4. Right-of-Way Vacation; KPB File 2023-024V

Request: Vacates a portion of Perkins Road and associated utility easements granted on Stanley's Meadow Vikki's Replat, Plat HM 99-30

**ITEM 4 - RIGHT OF WAY VACATION
PORTION OF PERKINS ROAD DEDICATED ON STANLEY'S MEADOW #7 (PLAT HM 87-45) AND
STANLEY'S MEADOW NO. 13 (PLAT HM 93-34)**

STAFF REPORT

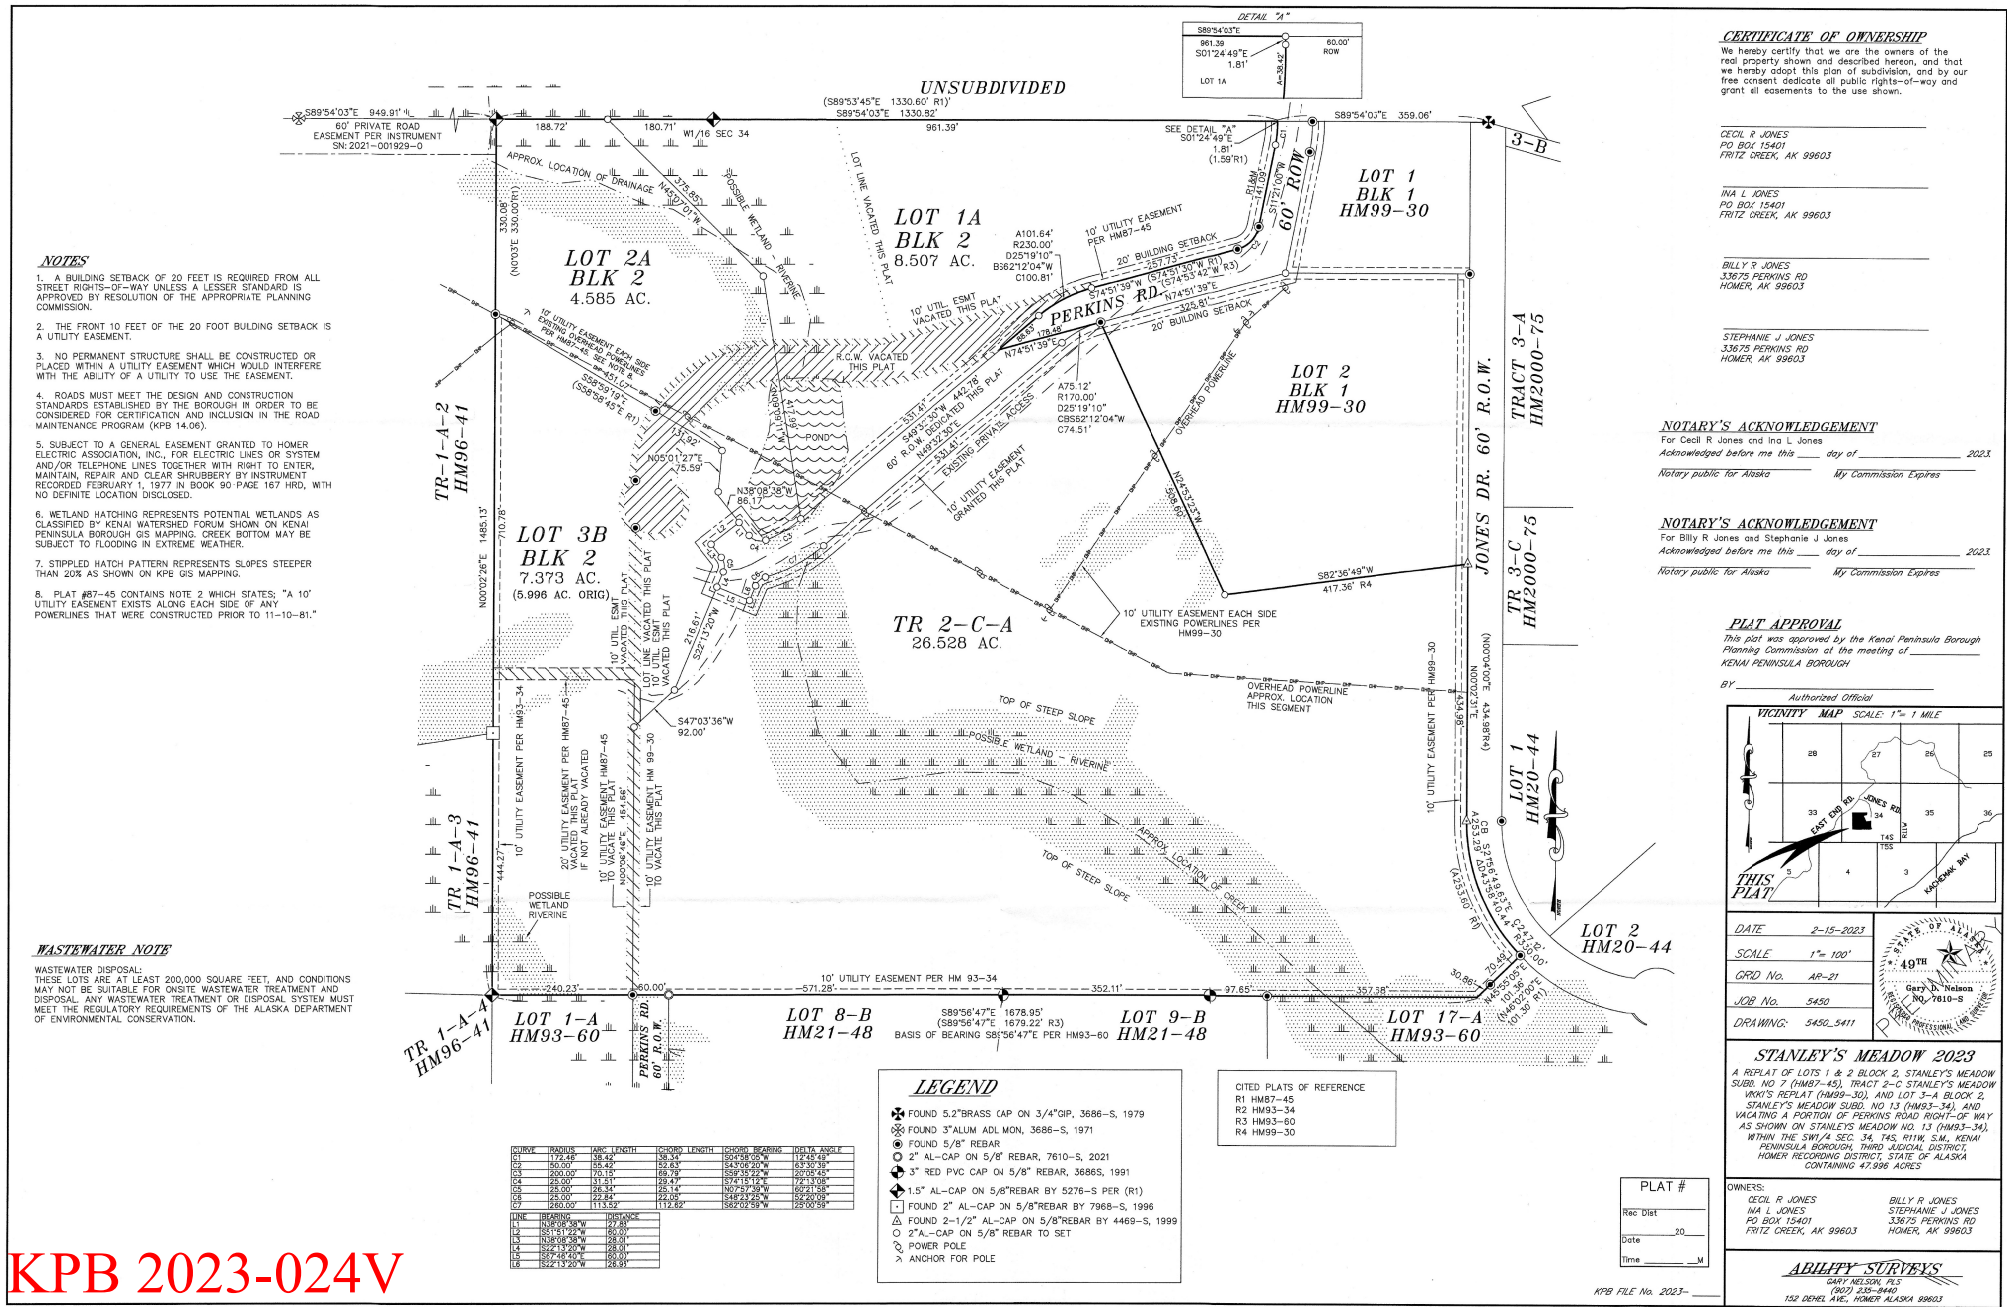
KPB Roads Dept. comments	Existing access is outside the proposed ROW. There appears to be a large amount of debris within the proposed ROW.
SOA DOT comments	No comment - engineering

A few concerns have been mentioned by the KPB Roads Department. The plat intends to dedicate the new right-of-way but portions will be parallel to a private access. The concern will be that the right-of-way will start within a public use dedication and then will begin to meander onto private property and then back into the dedication. This could cause some trespass issues. The Roads Department additionally mentioned that there appears to be multiple items within the proposed dedication area.

Staff will be recommending that the vacation be subject to the currently constructed roadway be within the newly proposed dedication. Staff usually recommends the dedication be centered on the existing travelway but due to some existing improvements that may cause encroachment issues. Staff will be satisfied if the roadway is within the dedication. The approval of the plat will require confirmation that the dedication will not cause any encroachment issues. If permanent structures are determined to be within the new dedication, the owners will need to work with staff to resolve the issue. Any items that are not permanent will be required to be moved with proof provided showing there will be no encroachments within the new dedication prior to finalizing the plat.

HEA	HEA has no objection to the vacation of the platted utility easements as depicted on this utility easement vacation exhibit drawing. HEA will request 30 foot wide utility easements on all single phase overhead electric lines during the platting review.
ENSTAR	No comments or recommendations
ACS	No objections
GCI

Based on consideration of the merits as per KPB 20.65.050(D) as outlined by Staff comments, Staff recommends **APPROVAL** as petitioned, subject to:

1. Consent by KPB Assembly.
2. Compliance with the requirements for preliminary plats per Chapter 20 of the KPB Code.
3. Grant utility easements requested by the utility providers.
4. Submittal of a final plat within a timeframe such that the plat can be recorded within one year of vacation consent (KPB 20.70.130).
5. The new dedication encompasses the existing travelway.
6. No encroachments may be created with the new dedication.
